Center for Auto Safety White Paper on Concerns With Chrysler Recall of the Jeep Grand Cherokee and Liberty Presented to NHTSA July 1, 2013

Chrysler has responded to the National Highway Traffic Safety Administration's request that it recall the Jeep Grand Cherokee and Liberty that have fuel tanks installed behind the rear axle for defects in their fuel systems with several specious arguments

Figure 1. A comparison with the subject Jeeps and other vehicles that Chrysler had purported to show had worse rear impact fire performance but which had no deaths due to fire in FARS in rear impacts where there was a fire in the listed vehicle.

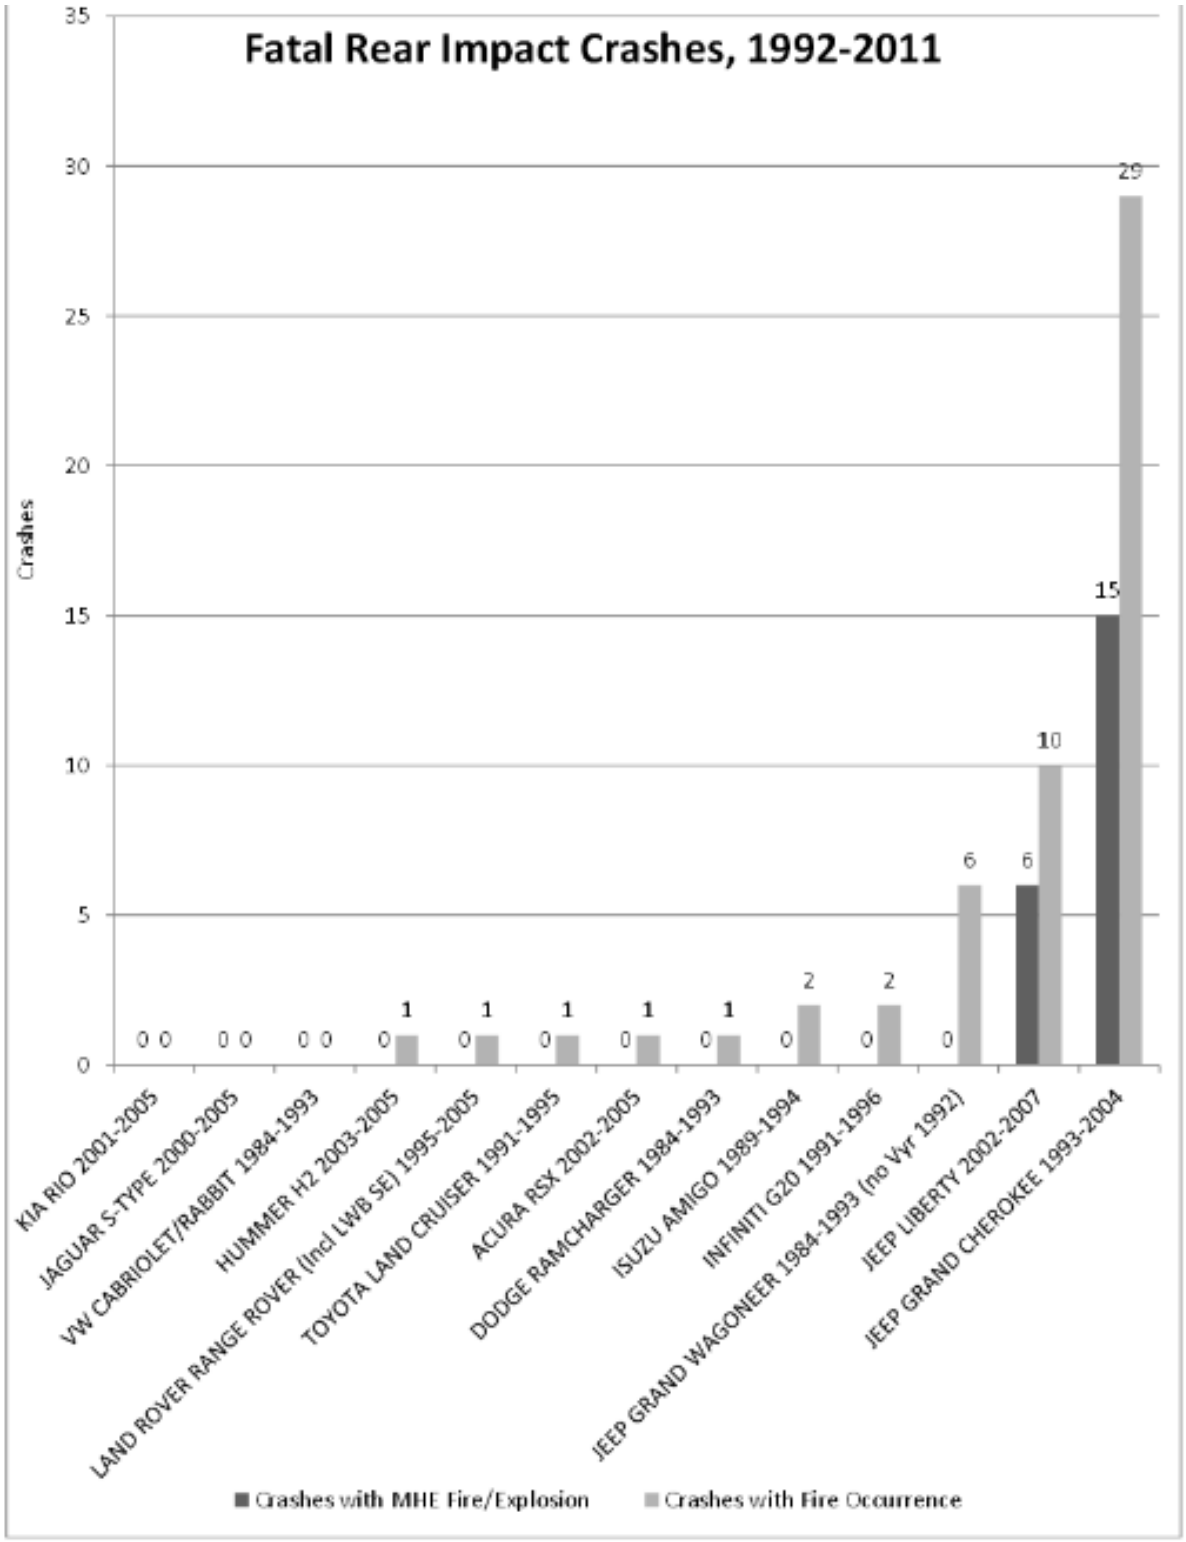
Chrysler has produced various tables that claim to show that Jeep Grand Cherokee and Liberty models have crash fire rates that are no worse than most other vehicles. We looked at the FARS files from 1992-2011 for the 31 vehicles where some or all of the vehicles were made in 1993 or later and found quite a different picture. Figure 1 shows that the Grand Cherokee and Liberty had 21 crashes (15 for the former and 6 for the latter) where fire was listed as the most harmful even and 39 crashes where there was fire (29 and 10, respectively). By comparison, eleven of the Chrysler so-called comparable vehicles did not have any crashes where fire was the most harmful event. Thirteen more vehicles had only one or two rear impact fire crashes. Only the 1994-2004 Ford Mustang has a comparable Fire-MHE fire rate. [5] <u>What Chrysler was doing was counting trauma deaths along with fire deaths knowing that compact vehicles like the 2300# Toyota MR2 would always have a higher fatality rate due to trauma versus fire compared to the 4100# Grand Cherokee</u>.

Chrysler included (Appendix D) an extensive discussion of confidence intervals in an attempt to show that one could not draw firm conclusions from the data where there were relatively small total numbers of relevant crashes. However, it is easy to see that the discrepancy between the performance of the subject Jeeps and other vehicles in Figure 1 is quite strongly indicative of a genuinely different crash experience between them and other vehicles in this chart. Similarly, the difference in the FARS data on Jeeps with fuel tanks mounted behind and ahead of the rear axle shows quite statistically different performance in the field. Chrysler does not discuss this appendix in the text of its June 18 letter because Appendix D shows that one cannot rely on the data behind its misleading comparison of various other makes and models to the Jeep Grand Cherokee and Liberty because the sample size and number of fatal fire crashes in such other models is so small.

Figure 2. A chart submitted by Chrysler as part of their early response to NHTSA's investigation. Note that while Chrysler combined sisters and clones in most cases, it did not combine the very small volume Honda Passport with its sister Isuzu Rodeo.

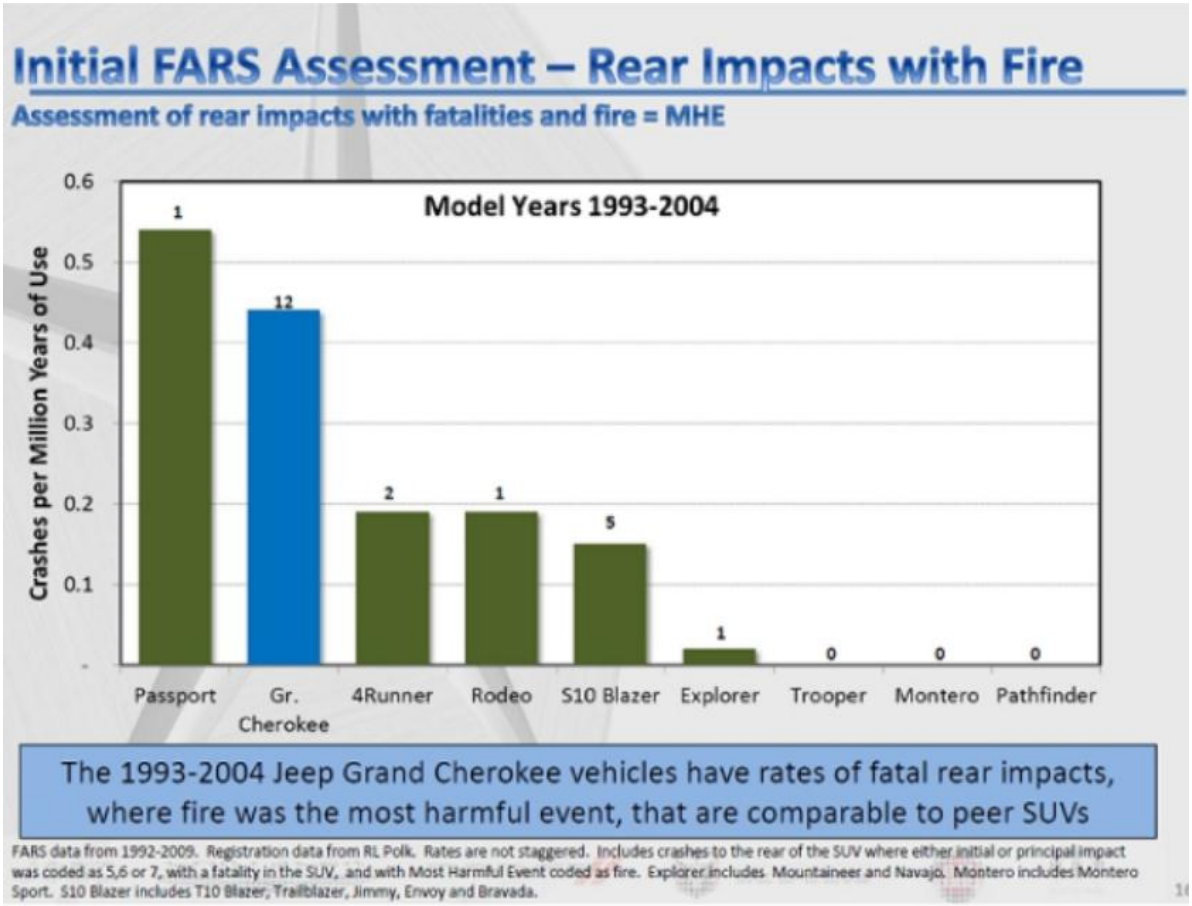
Looking at Chrysler's own chart which normalized these results (Figure 2) for the Grand Cherokee – with 12 cases where fire was the most harmful fatal event – had 4.4 per hundred thousand vehicle-years of use. The Honda Passport, which is a sister of the Isuzu Rodeo and should have been included with them, had only one crash on this chart, but when we looked at this case it was not even a rear impact but rather a frontal with a Chevrolet Tahoe.[6] (Also, because of the small population of these vehicles, there were a

very small number of vehicle years of use). None of the other vehicles in this chart had a rate greater than 2 per hundred thousand vehicle years of use.
